MEETING: REGULAR MEETING OF THE PLAN COMMISSION

DATE & TIME: Monday, February 12, 2024 at 6:30 PM

- B. American Architectural Group, Agent for Washington Drive LLC, Property Owner, and Midwest Products, Inc.- W129 N11025 Washington Drive. Site Plan Review for a new 52,038 sqft manufacturing and warehouse building - Revised Building Elevations. (ACTION)

- C. Excel Engineering, Inc., Agent for Bethlehem Lutheran Church, Property Owner N100 W14290 Bel Aire Lane. Site Plan Review for a 23,471 sqft Building and Parking Expansion-Revised Site and Landscaping Plans. (ACTION)

CIVIL LANDSCAPE AND RESTORATION PLAN

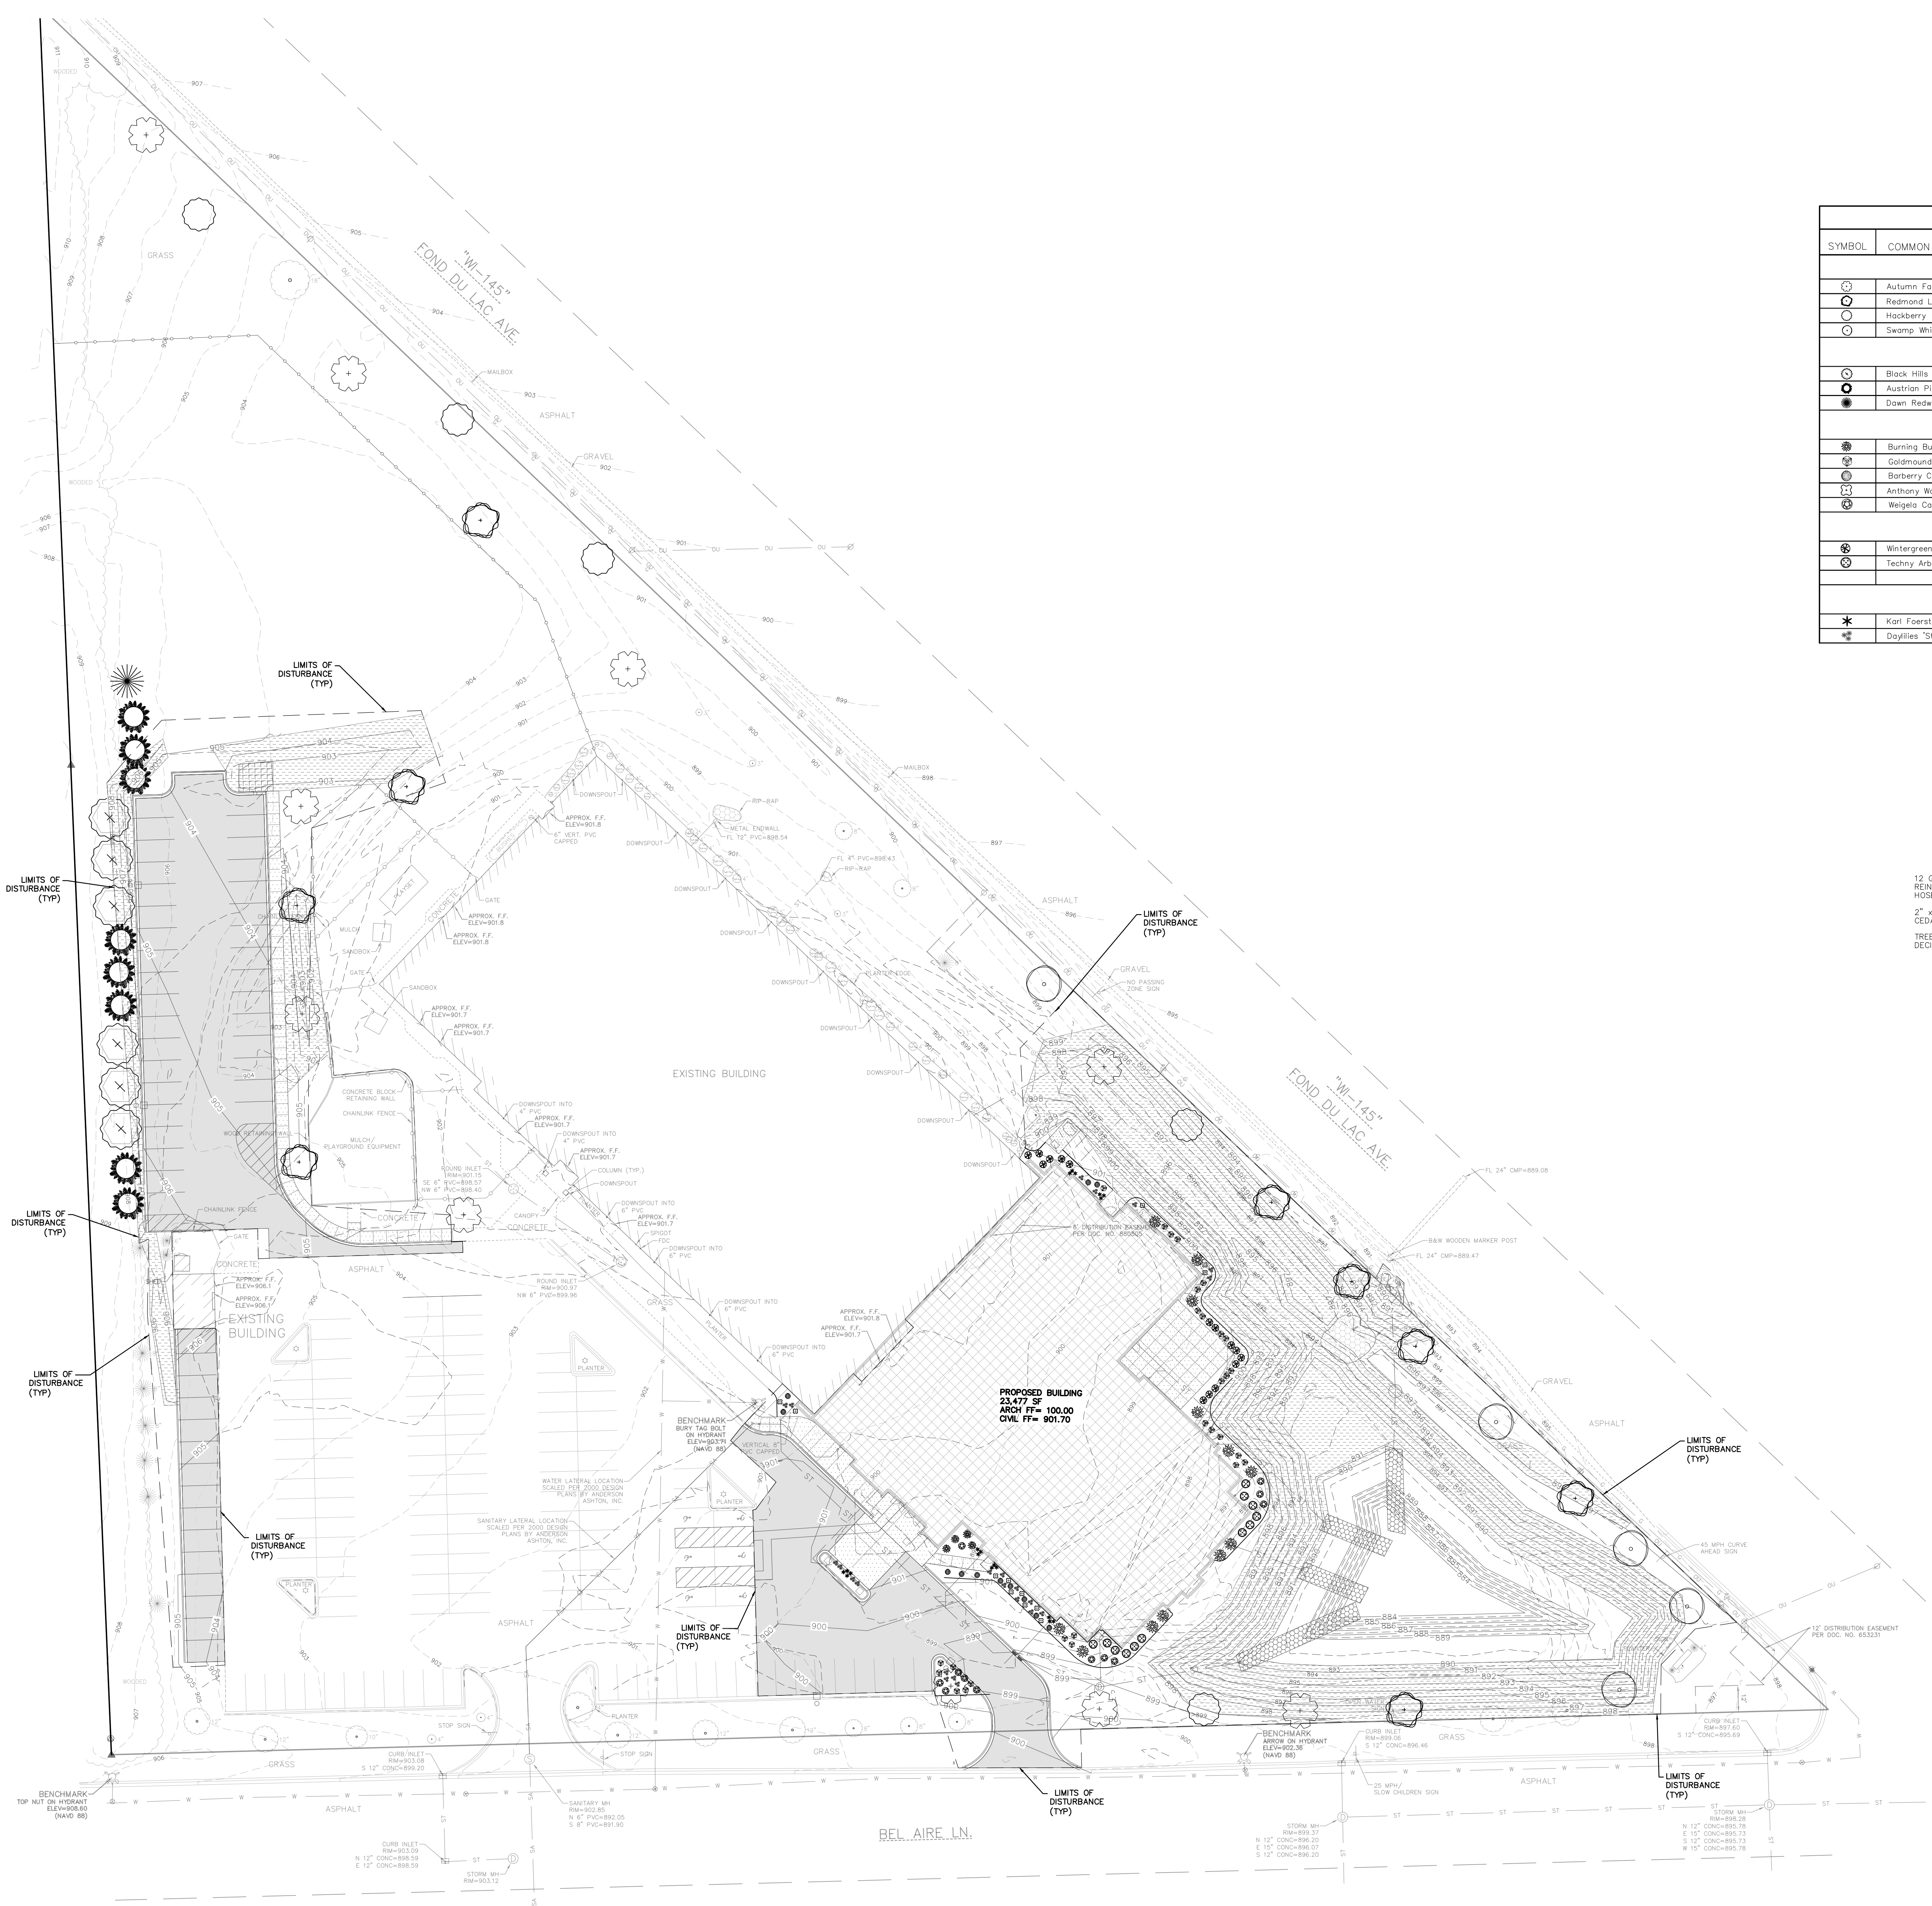
7. Additional deciduous and evergreen trees and shrubs shall be installed along the west property line around the new parking lot perimeter in an amount and type necessary to provide screening from the residential lots to the west. As an alternative, install a minimum 6' high wood privacy fence along the property line for a 15' distance north and south beyond the ends of the new parking lot.

9. A revised landscape plan including a revised plant list with installation sizes meeting minimum requirements and addressing all Village Staff comments and recommendations presented in the Staff Report & Recommendation (dated 1/8/24) shall be prepared and submitted for review and approval by Village Staff prior to issuance of a building permit. Said plan to include the requirements of Conditions #8 and #9 above.

Excel Response: Landscape plan updated. Please refer to sheet C1.4. for proposed landscaping.

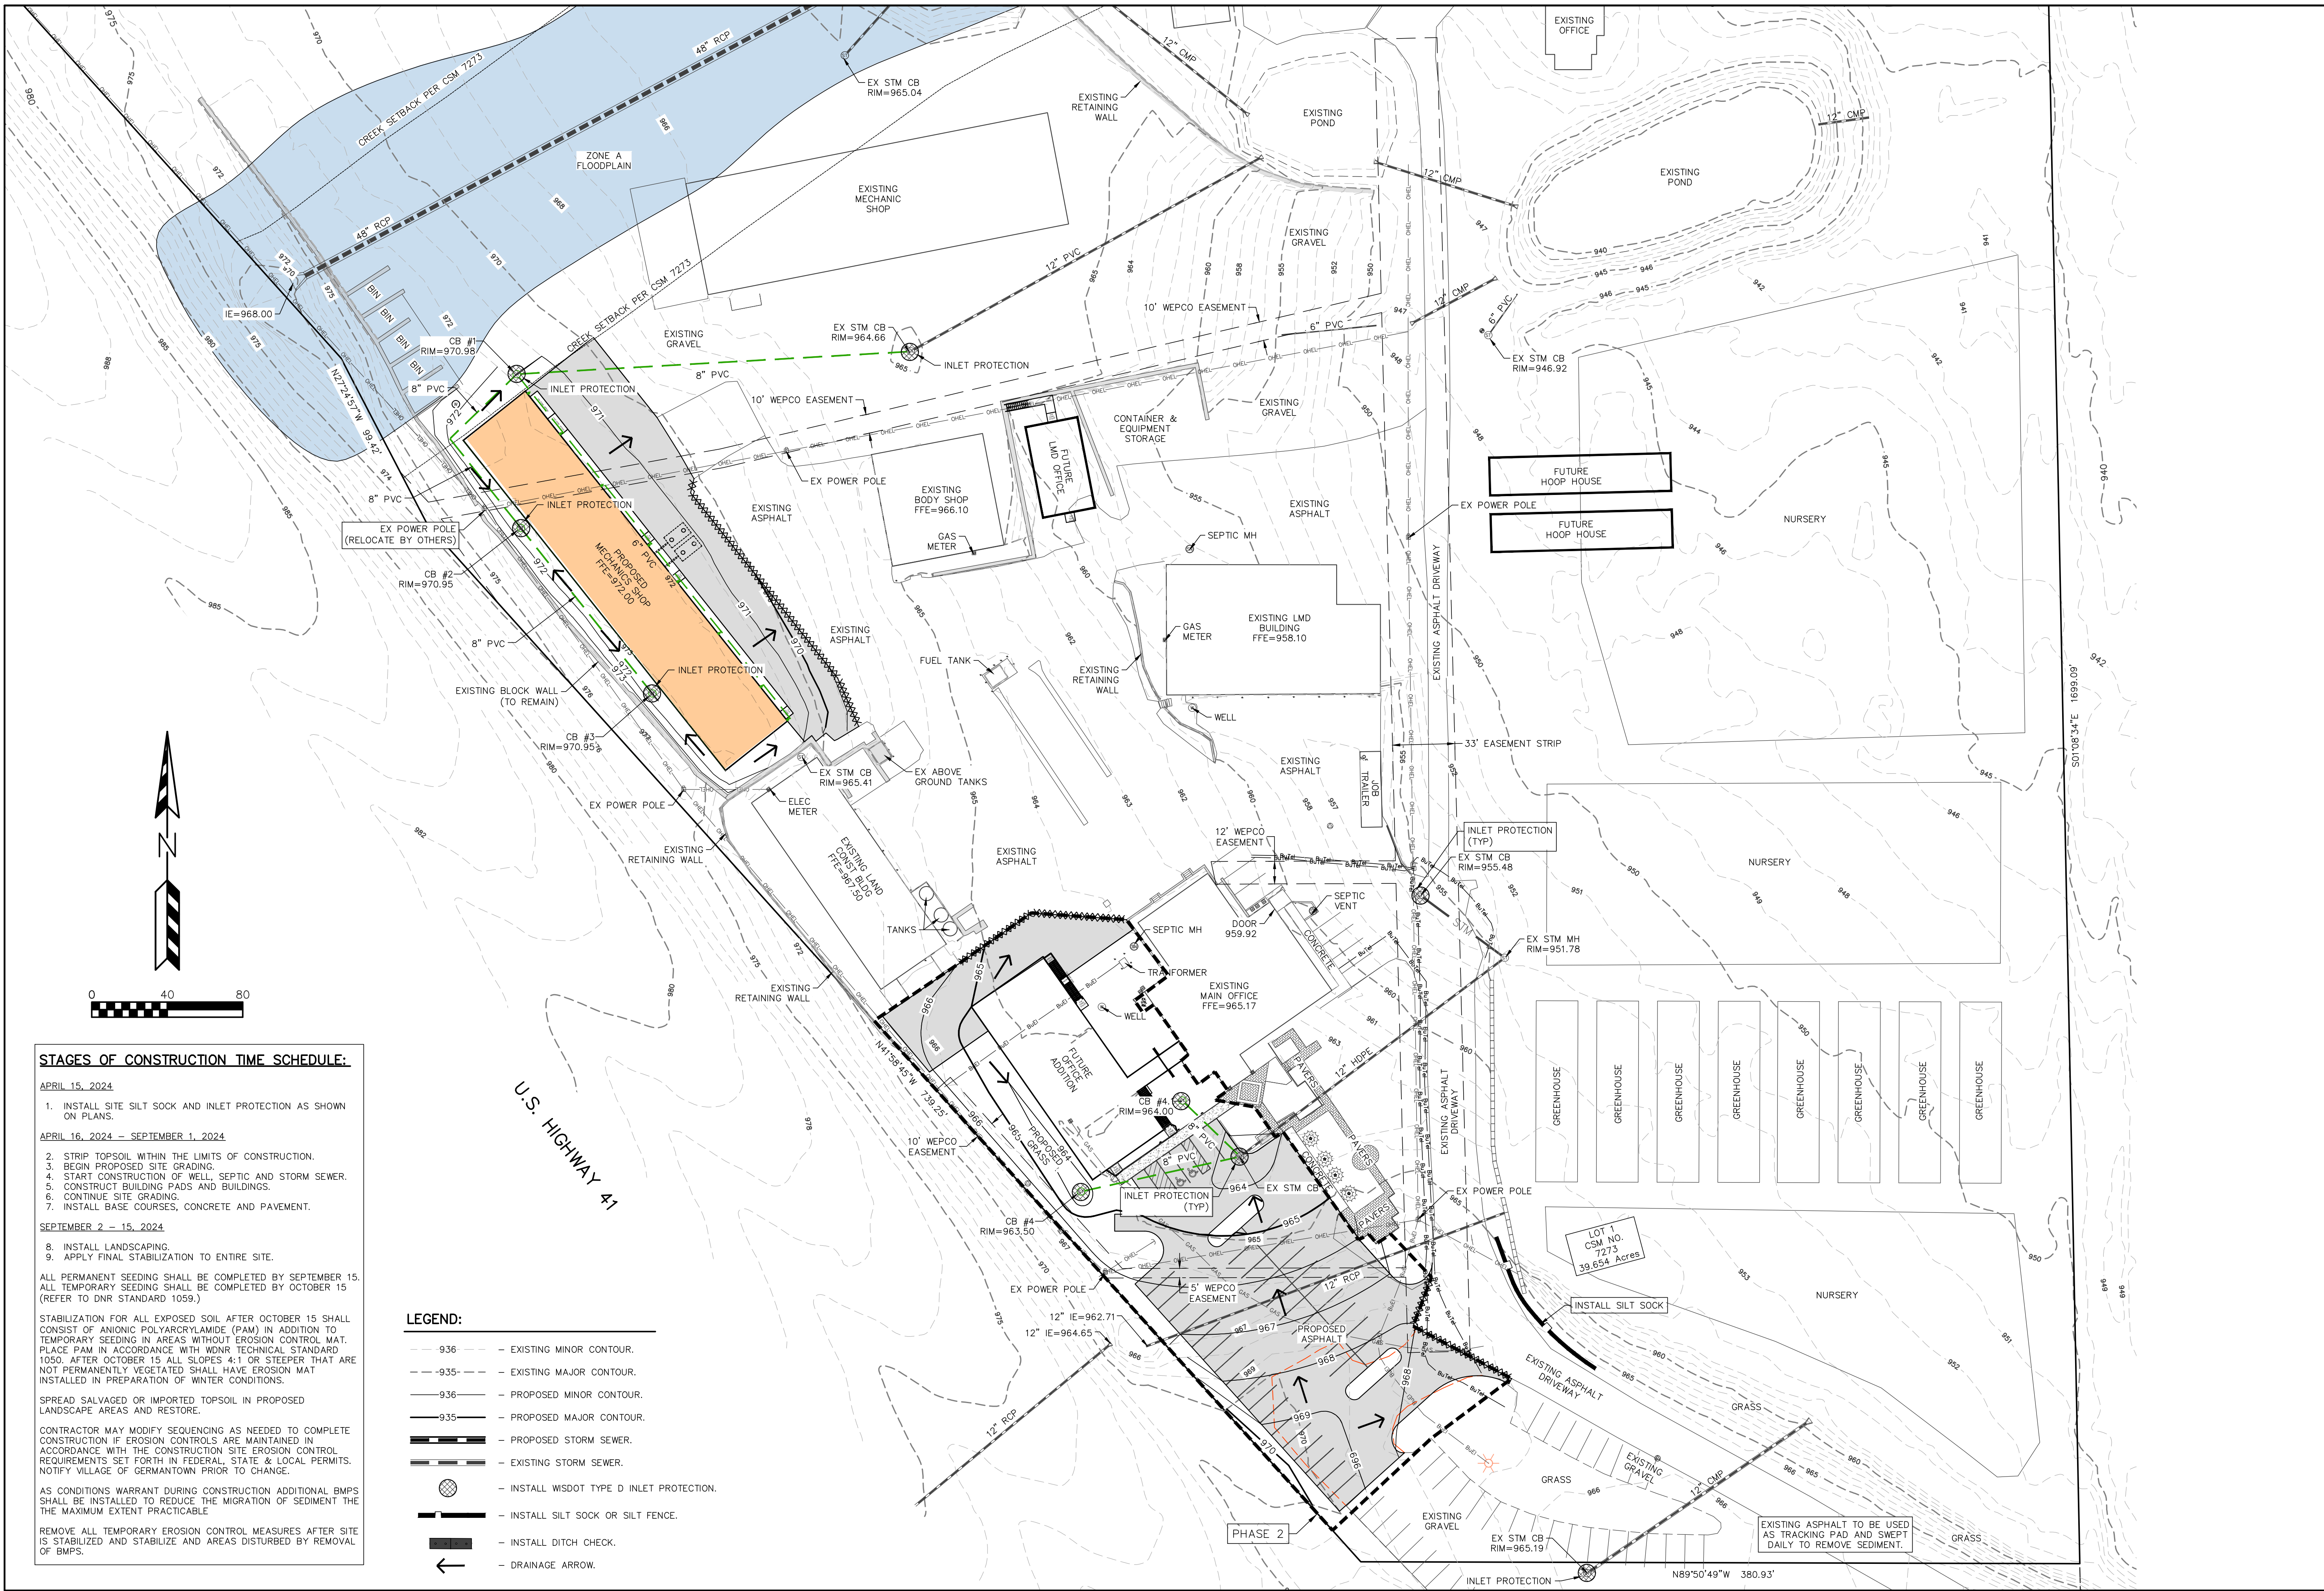
1. Revise swale to meet the Village requirement of 1.0% minimum slope.
2. Provide calculations showing the swale is size appropriately.
3. Due to the amount of roof water this swale will convey, in addition to erosion control details on sheet C1.06, provide erosion matting for concentrated flows in the swale.

2. Provide calculations showing the swale is size appropriately.
See attached for runoff and swale capacity calculations.
3. Due to the amount of roof water this swale will convey, in addition to erosion control details on sheet C1.06, provide erosion matting for concentrated flows in the swale.
This has been added.
